1NSW-50
Instrument Room Ventilation
Unit 4 Return Line

LIVSEY & COMPANY, INC.
DONALD C. COOK NUCLEAR PLANT

DWN. JG	DATE 8-20-71	CONTAIN. & UNITY.	
CKD. GN	DATE 10-8-71	DWG. NO. 1-NSW-50	REV. 5
ISSUED			
REF. DWG. 1-5497A

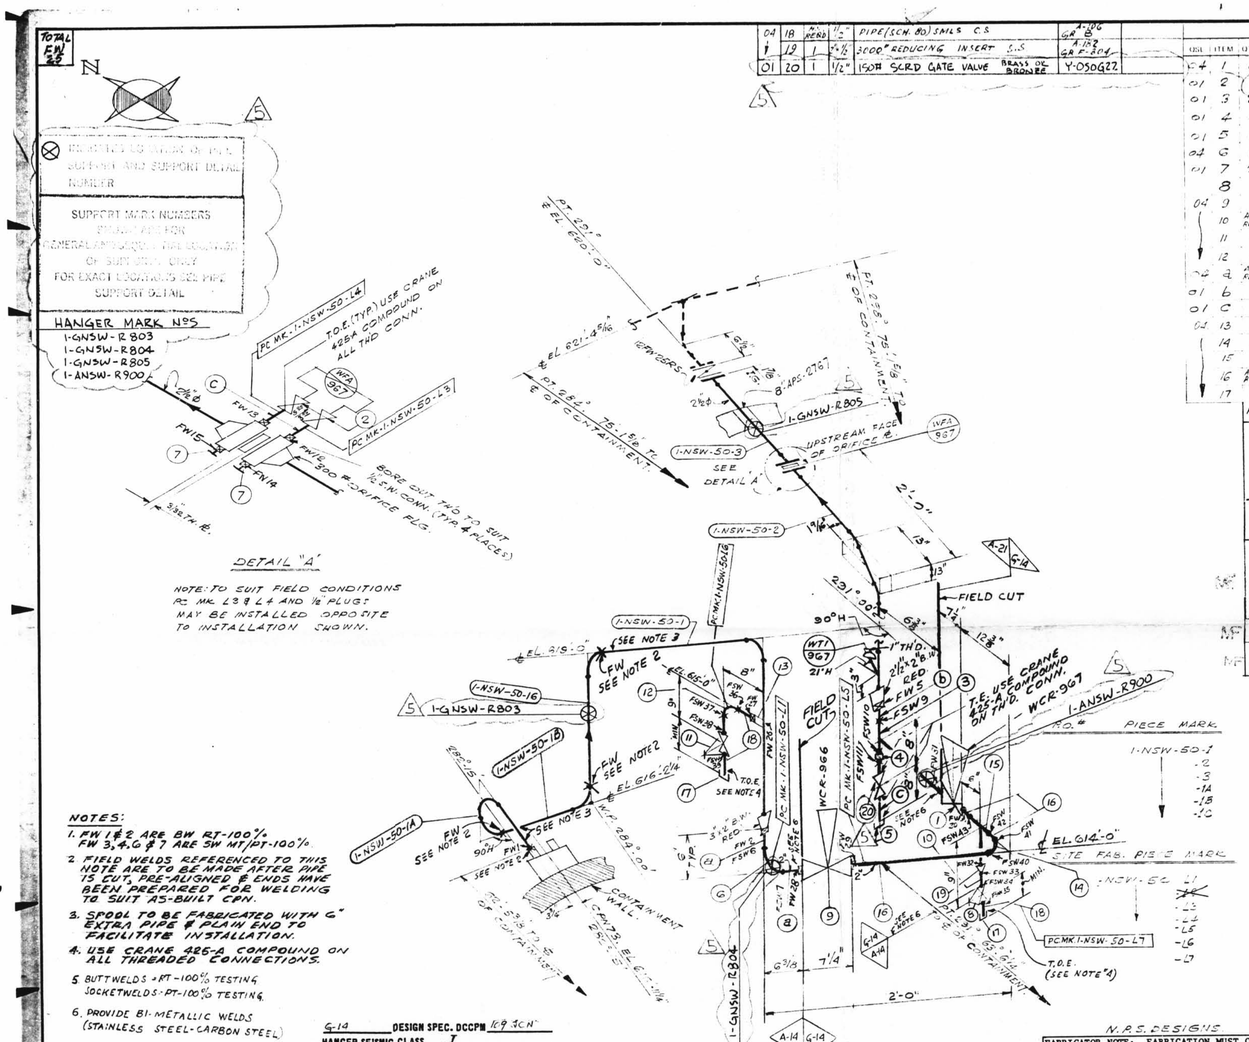
REV.	DATE	DR. CHK.	DESCRIPTION	REMARKS
1	18 Aug 72	I.P.	REVISED BY NPS DESIGNS: REMOVED HOLD ON PC MK 1-NSW-50-1, ADDED: PC MKS 1-NSW-50-1A, 1B & 1C, NOTES 2 & 3 FWS. PER DWG 1-5497A, REVISION 5	FIELD ACTION REQ'D —
2	1-20-76	HM	REVISED BY A.E.P. DESIGN PER REC-DC-12-571 TO REFLECT AS BUILT WHEN CONTROL VALVE WAS ADDED.	NO ACTION REQ'D.
3	11/12/82	K.A. E.J.G.	PER REC DC-12-2549 ADDED: PIPE SPEC G-14 DIM'S, PC MK L5, L6 & L7, WELD BOX, NOTES 5, 6 & 7, FIELD WELDS FW 26 TO 32, FSW 33 TO 43. ITEM NOS 9 TO 19 TO B.M. RE-VISED ITEM Nos 15, 6 & 8 W.R.W. DELETED PC MK L2, ADDED DIM'S FOR OFFSET.	FIELD ACTION REQ'D
4	5/14/82	J.M. LB	PER REC-DC-12-2549 ITEMS 10 & 16 WERE SCH. 40 S PIPE	FIELD ACTION REQ'D
5	5/1/84	DK/ LB	PER REC-DC-12-2876 ADDED ITEM 20 AND SUPPORT MARK Nos, SUPERSEDED HGR ISO 1-GNSW-50. ALL ABOVE TO REFLECT AS-BUILT CONDITIONS.	NO FIELD ACTION REQ'D
